World Forum for Harmonization of Vehicle Regulations

Working Party on Noise and Tyres

Tyres: UN Regulation No. 75 (Tyres for L-category vehicles)**Proposal for amendments to UN Regulation No. 75****Submitted by the experts from the European Tyre and Rim Technical Organization***

Annex 2, amend to read:

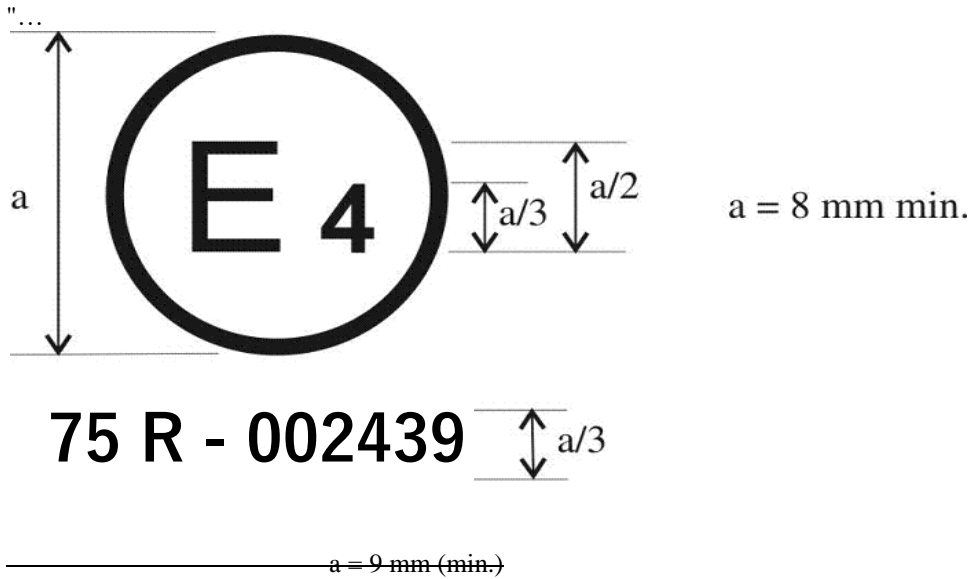
The above approval mark affixed to a tyre shows that the type of tyre concerned has been approved in the Netherlands (E4) pursuant to Regulation No. 75 under approval number ~~022439~~-002439. The first two digits of the approval number indicate that the approval was granted in accordance with the requirements of Regulation No. 75 in its original form.

11. In Annex 2, there are two conflicting provisions concerning the minimum size of the approval mark. It is proposed to remove the larger of the two values.
